HISTORIC PRESERVATION BOARD

HISTORIC PRESERVATION BOARD MEETING

**PUBLIC HEARING
58 FORE STREET (former Portland Company Complex)**

TO: Chair Sheridan and Members of the Historic Preservation Board
FROM: Deb Andrews, Historic Preservation Program Manager
DATE: January 31, 2019
RE: February 6, 2019 PUBLIC HEARING

① East Elevation
1/8" = 1'-0"

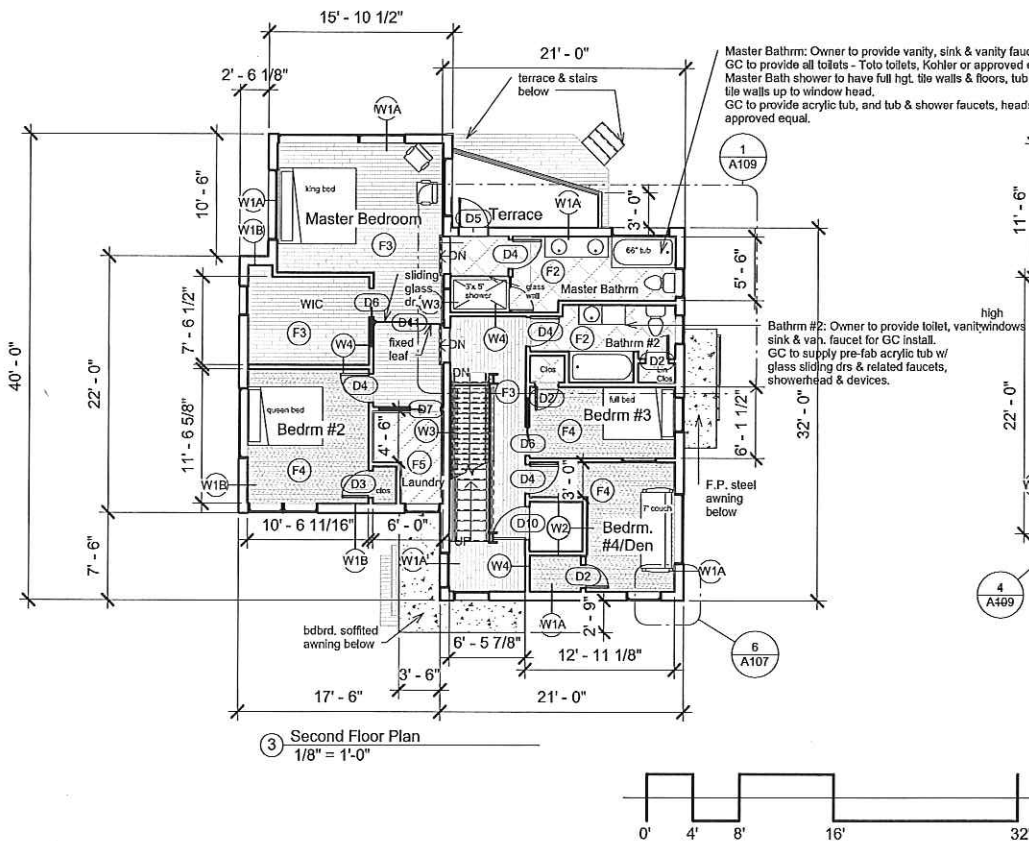
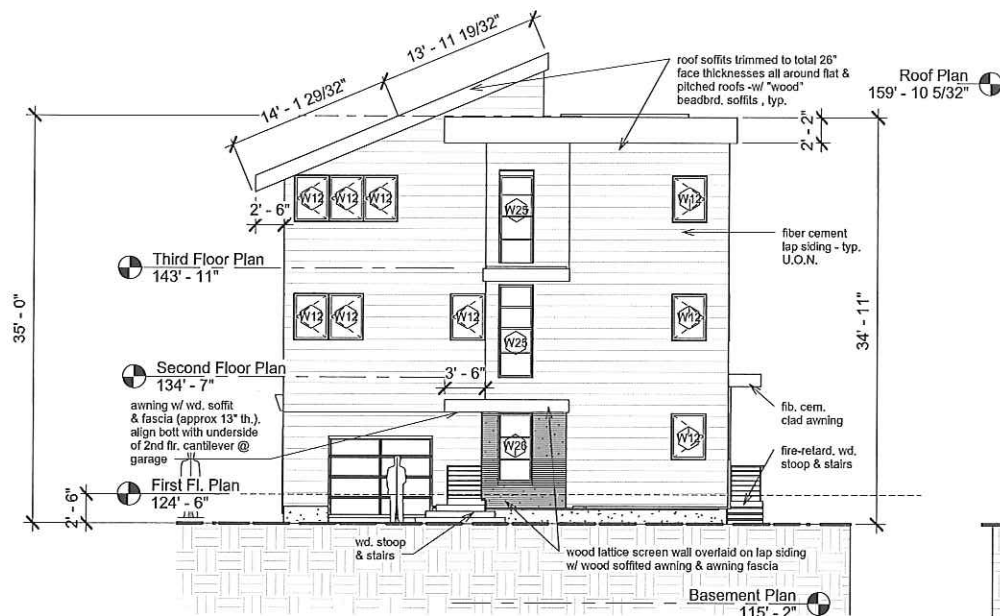
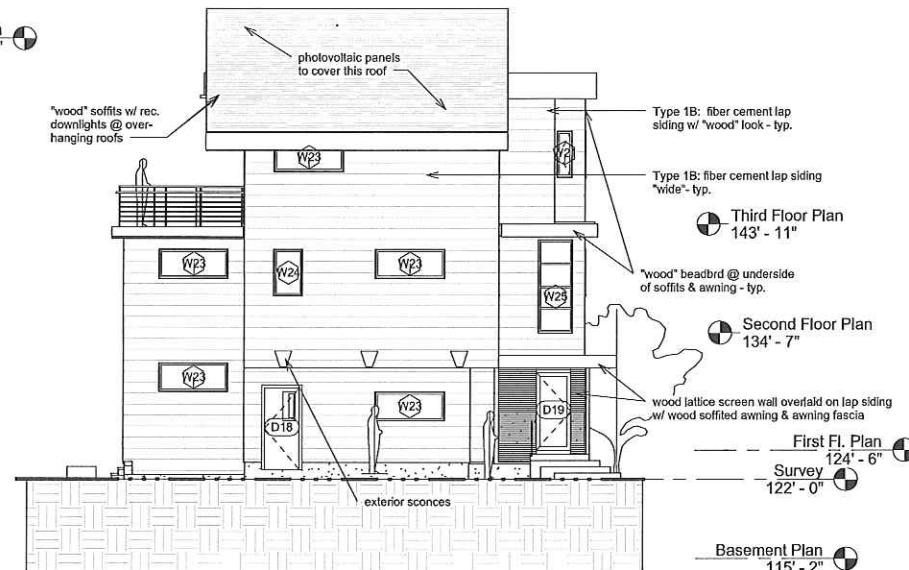
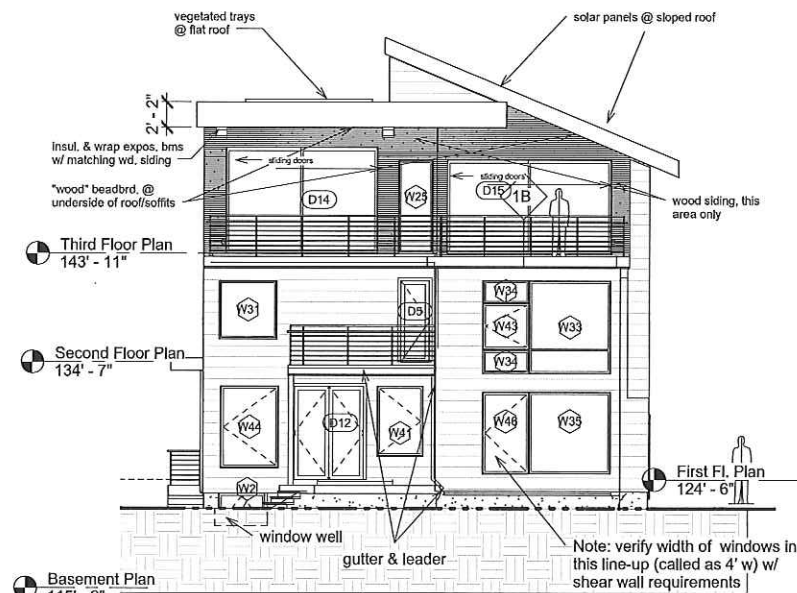
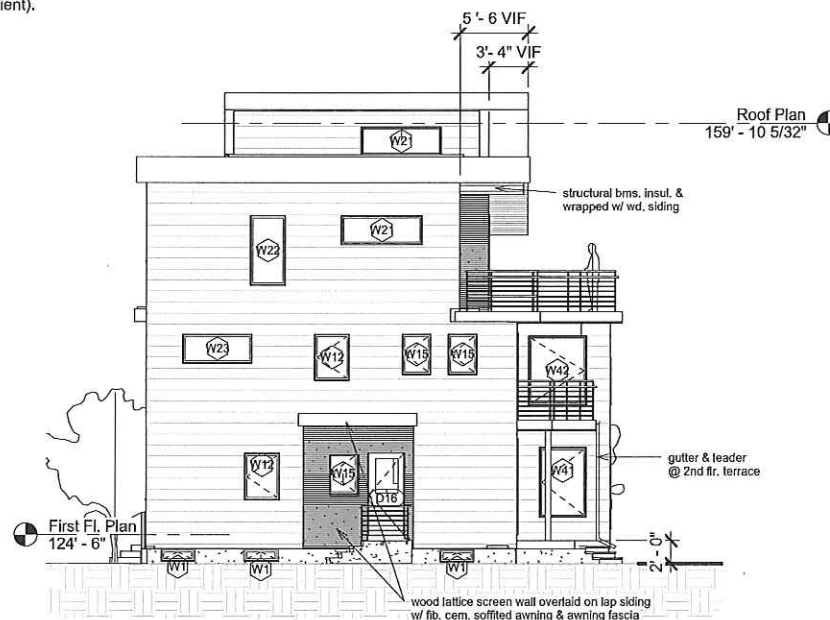
- Facade composition and Windows: The types of windows were reduced and revised to include a “family” of window types. These are vertically proportioned and consistent throughout the street-facing facades, though a different size and proportion than is found in the traditional buildings. Are the concerns about the facade composition and window types addressed?

- Materials: Are the material selections and placement considered “harmonious with the character defining materials and architectural features of the neighborhood?” These were revised to provide a clapboard-style material as the primary siding with a naturalized wood material appearing at the entrance

- *B-3 Main Roofs and Subsidiary Roofs:* The flat roof form should be the dominant roof form but **staff question whether the monopitch roof is sufficiently subsidiary. The overhang and depth of cornice were reduced for the subsidiary roof – staff request the board to weigh in whether this can be considered clearly subsidiary.**

- *F-2 Window Types:* **More than two window types and sizes are used on the street-facing façades – a third type is added for the building entrance. The windows were revised to be in a family of proportions and type.**

- *G-1 Materials:* The proposal uses a cementitious board clapboard for the primary material that is considered consistent with the context predominantly of clapboard. **The unfinished wood is not typical as a material in this context and was revised to only appear as an accent material at the entrances now better meeting the standard.** The roofline soffits are treated with a “wood” beadboard finish.
- *G-2 Material and Façade Design:* The materials are placed appropriately to the façade design and their nature.
- *G-3 Chimneys:* Not applicable.
- *G-4 Window Types:* Overall, more than two window types are used in the building; but only two types appear on front facade. The predominant character in this context is vertical proportioned windows with one or two types visible from the street. Window detailing is consistent.
- *G-5 Patios and Plazas:* Not applicable.

- all siding at elevations visible from the street is the fiber cement dark-colored lap siding. however, a wood screen element is added around the main and side first floor entrances, including the part of the east facade that is under the awning. this screen will consist of horizontal slats through which the dark lap siding can be perceived. (I will have images for the presentation).

- the "anomalous" square windows at the third floor have been revised to be the same vertical 3'x4' windows used elsewhere
- the entrance stairs and related canopy have been revised to align with the leading corner of the adjacent building to the south (#106). The canopy has been beefed up so that it is a significant architectural element and the stairs have been revised to be a more street-oriented massing. (Note: moving the whole building out to this line is hard to justify, as it adds unnecessary square footage and mass at three floors - plus more cost!!)

COMMERCIAL ST. ELEVATION

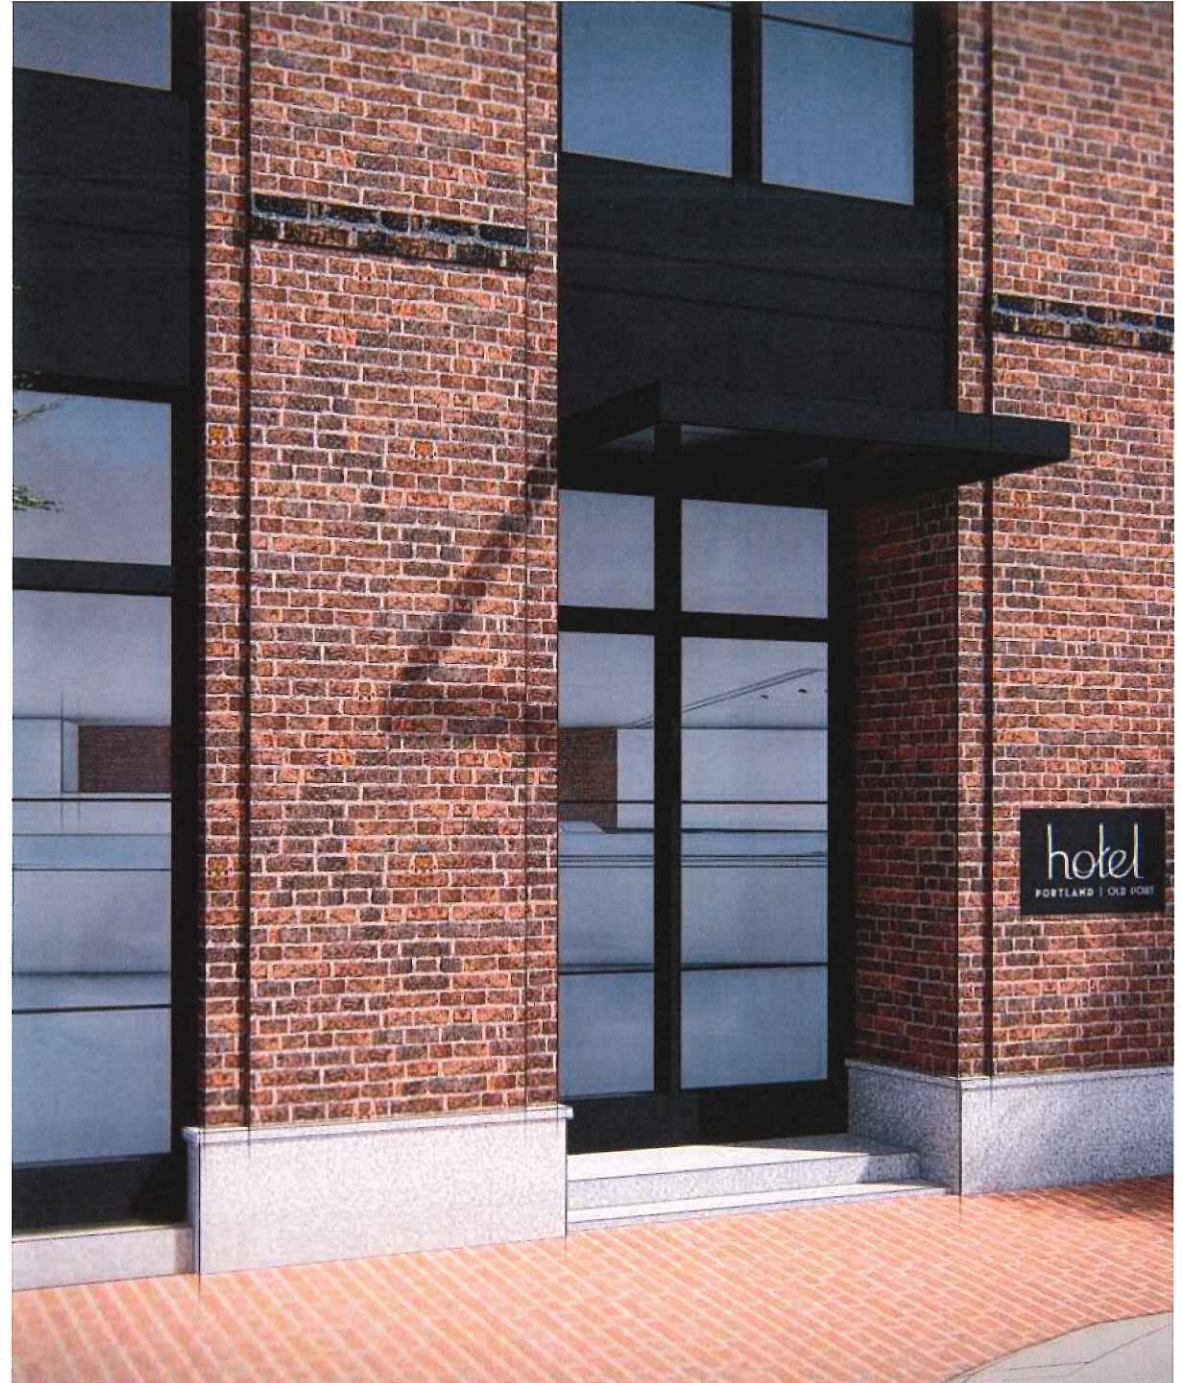
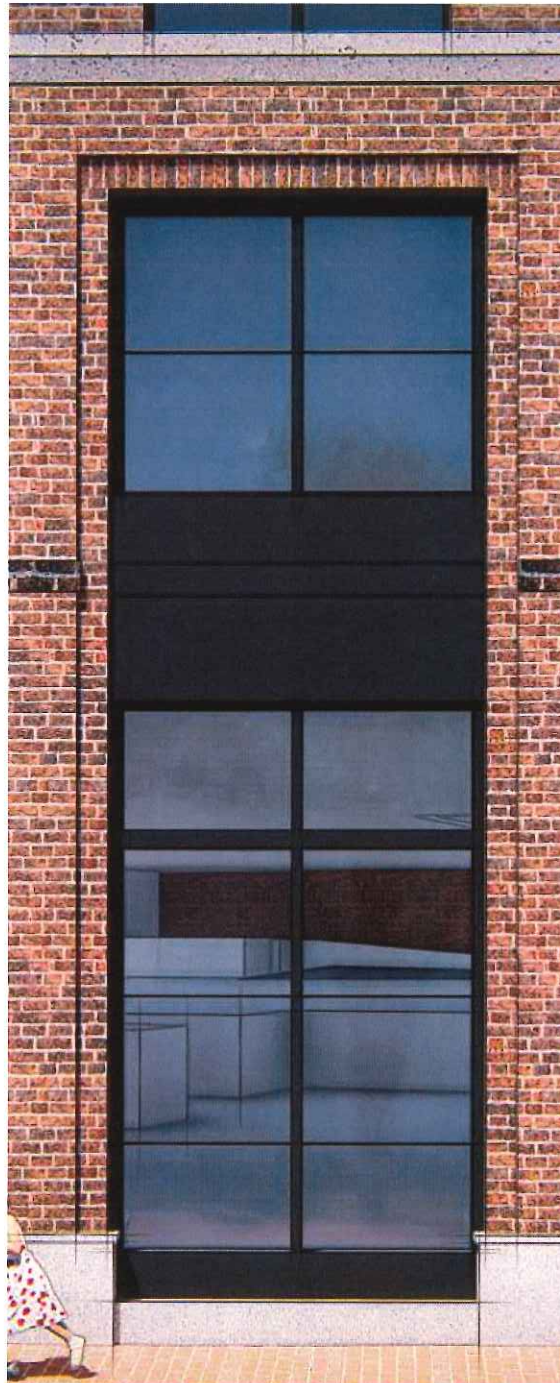
- Board members questioned why the window treatment proposed for the top floor of the Commercial façade (east side) was not consistent with that proposed for Center Street's top floor. On the Center Street elevation, the window treatment was consistent on all upper floor levels. On Commercial Street, the top floor windows were shown considerably larger than those on the floors below and the wide metal surrounds had been eliminated. In the view of the Board, the lack of metal framing served to exaggerate the fact that these windows were oversized and distinguished from all other windows on the building. Had a distinctive window treatment for this portion of the top floor succeeded in making the east and west ends of the floor more consistent, the different treatment might have been justified. But this was not the case.

- Noting that the details of the metal framing around windows and doors had been revised since the first workshop, Board members questioned whether the revised treatment would provide the 3-dimensional character and visual interest that the previous iteration provided. Although reveals were shown between metal panels, it was not clear the width of the reveals was sufficient to make them discernable or provide a shadow line.

- Board members noted the absence of a granite base at the ground floor level, which is a consistent feature on Commercial Street buildings.
- Concern was expressed about the building's lack of engagement with the street life of Commercial Street. Recognizing that the applicant wanted to limit the number of entries onto Commercial Street, Board members expressed the view that the one entry needed to be highlighted, not downplayed as shown. Questions were also raised about provisions for signage for the ground floor restaurant.

- One Board member raised questions about the revised treatment for the corner tower element and suggested consideration of fewer louvres to retain the sense of openness and transparency.

- LEVEL 01 – 02
 - Added granite base.
 - Glass canopy over Commercial Street entry
 - Modified egress door to match adjacent portals along Commercial Street, but with frosted/opaque glass.

- LEVELS 03 – 06
 - Changed all previous rust metal panel walls to brick.
 - Added articulation and wall "punches" along the public stairs.
 - Modified the 6th floor window detail to match on both Commercial and Center Street.

01 ROOFTOP TERRACE

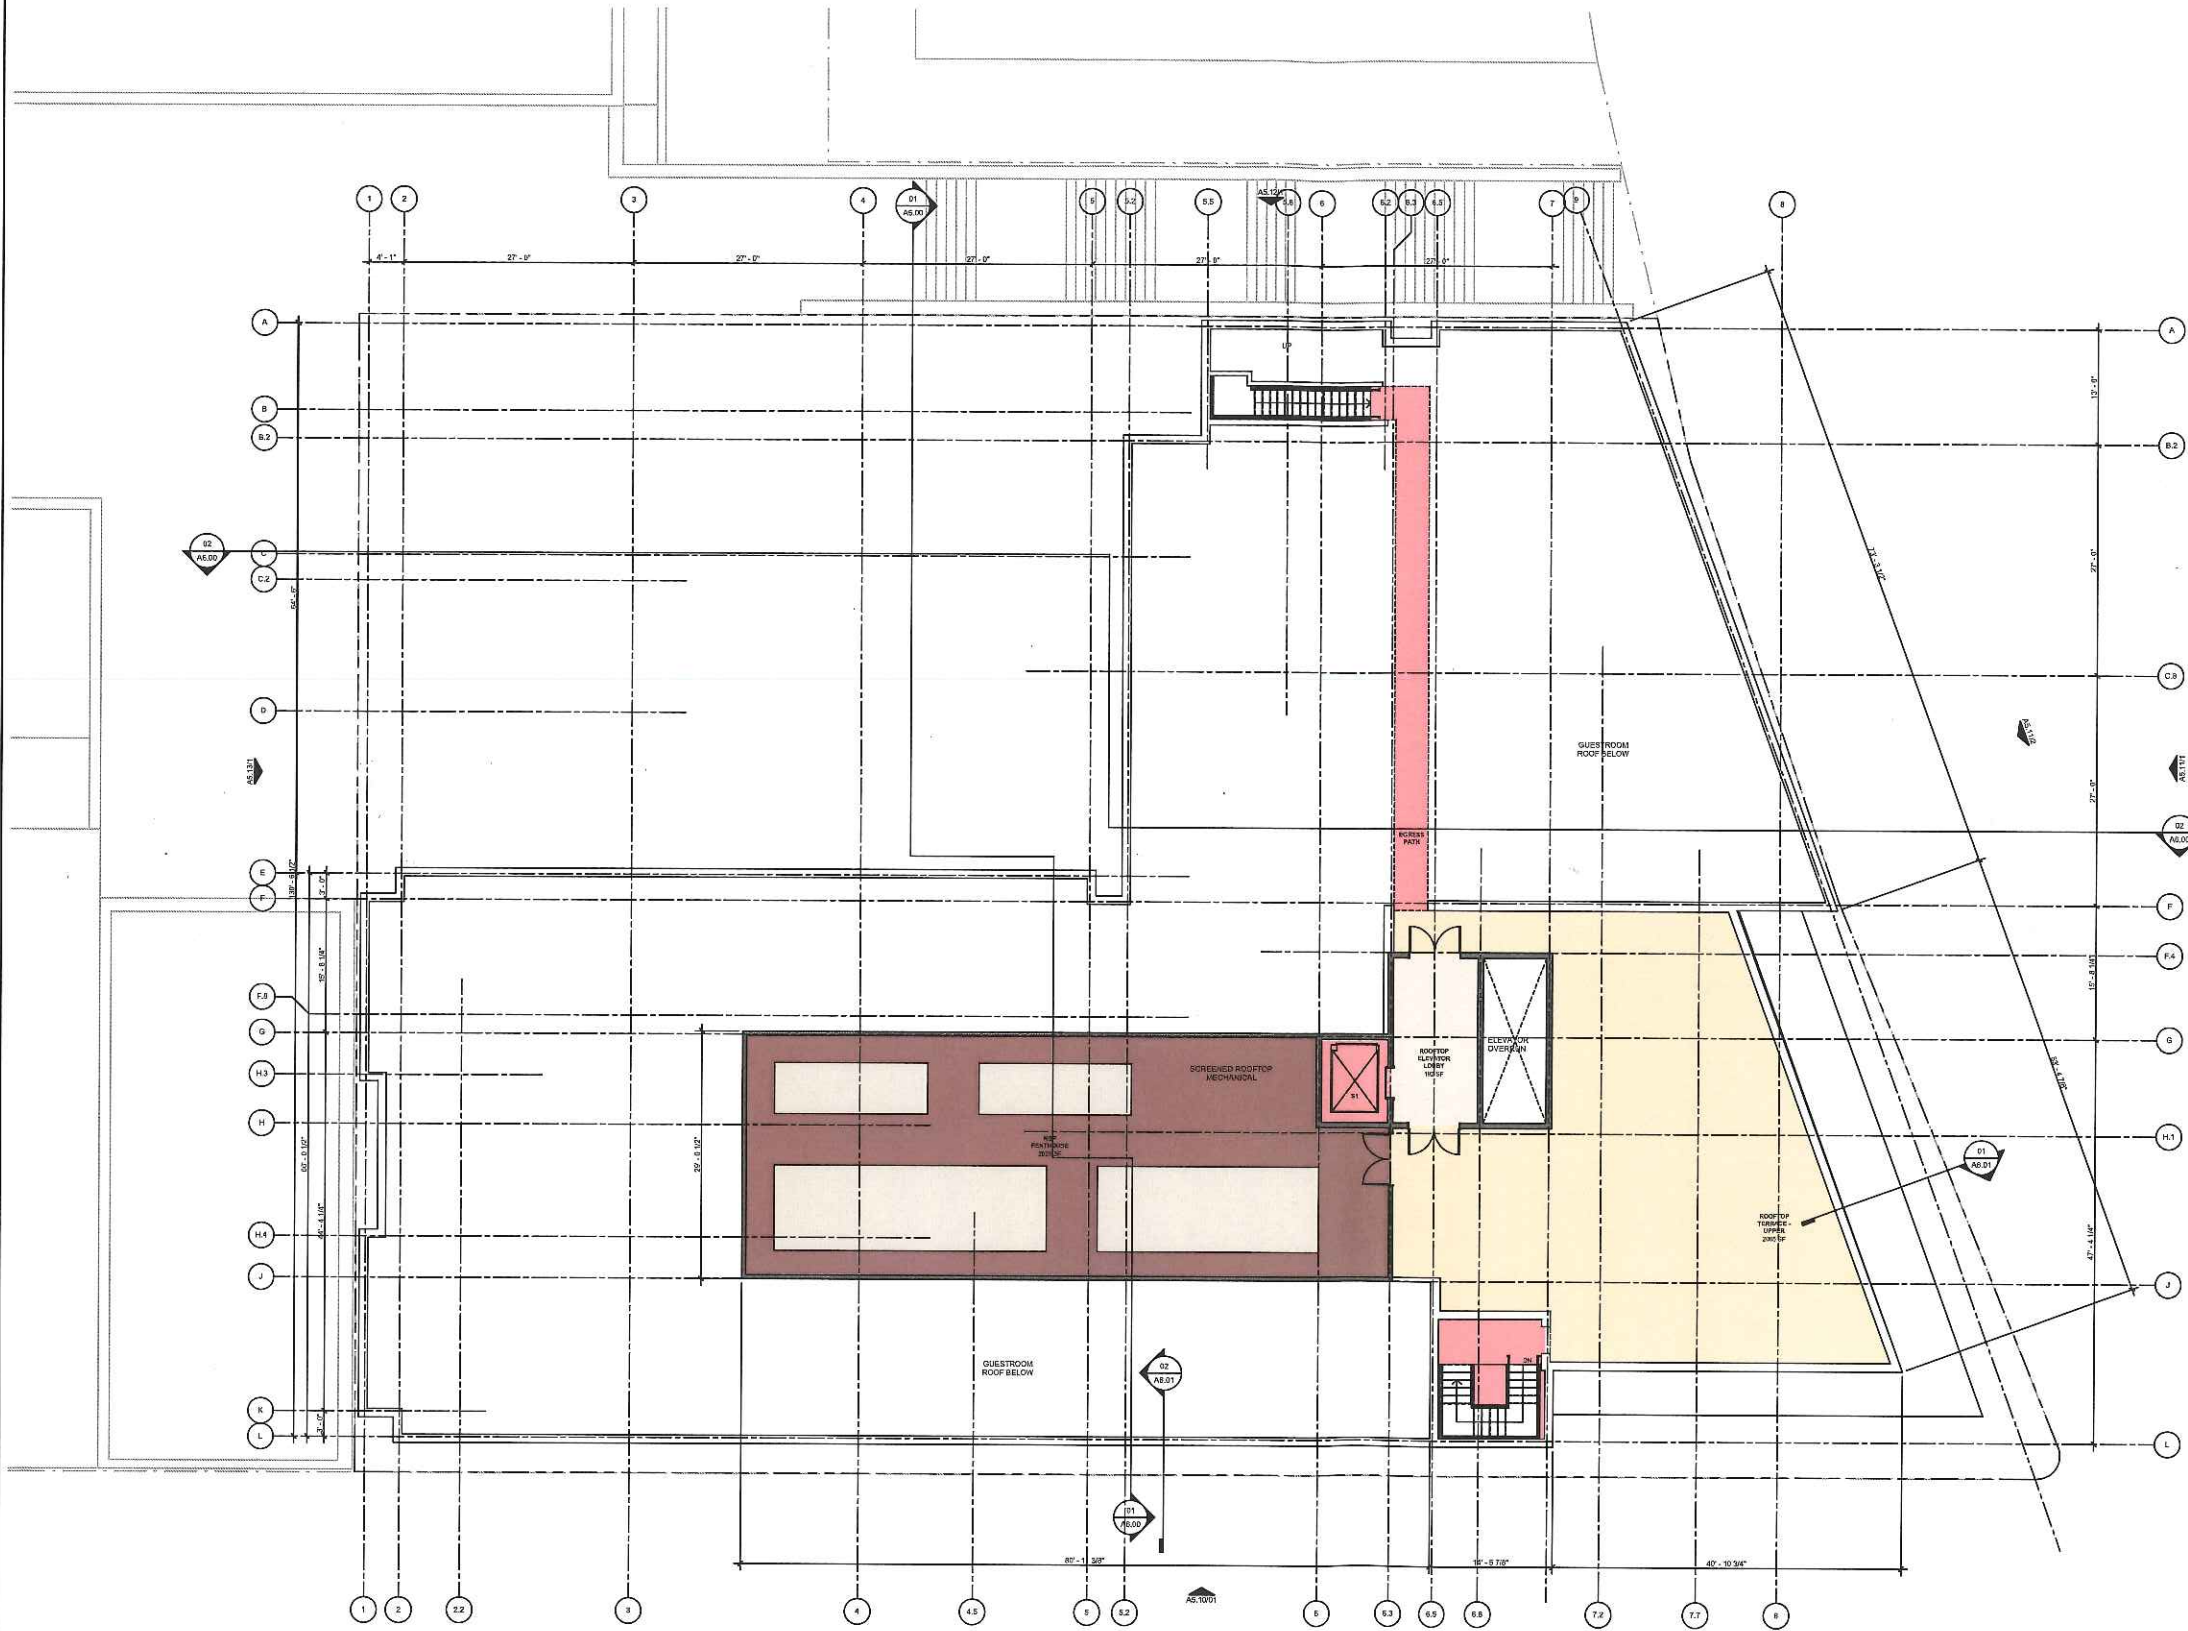
- Several Board members expressed opposition to the applicant's proposal to add a rooftop deck at the southwest corner of the building. They noted that the deck would necessitate an elevator overrun, an additional railing and other elements that would add complexity to the roofline. They also noted that the deck would exacerbate the building's lack of continuity between its east and west ends.

- Brick added above 6th floor window to maintain continuity with the rest of the building.
- T.O.S. (Open-Air Rooftop Terrace, occurring at the 65'-0" height limit)

- Modified previous metal railing to cable/wire system to help the railing be more discreet.
 - Enclosed the stairs at this level.
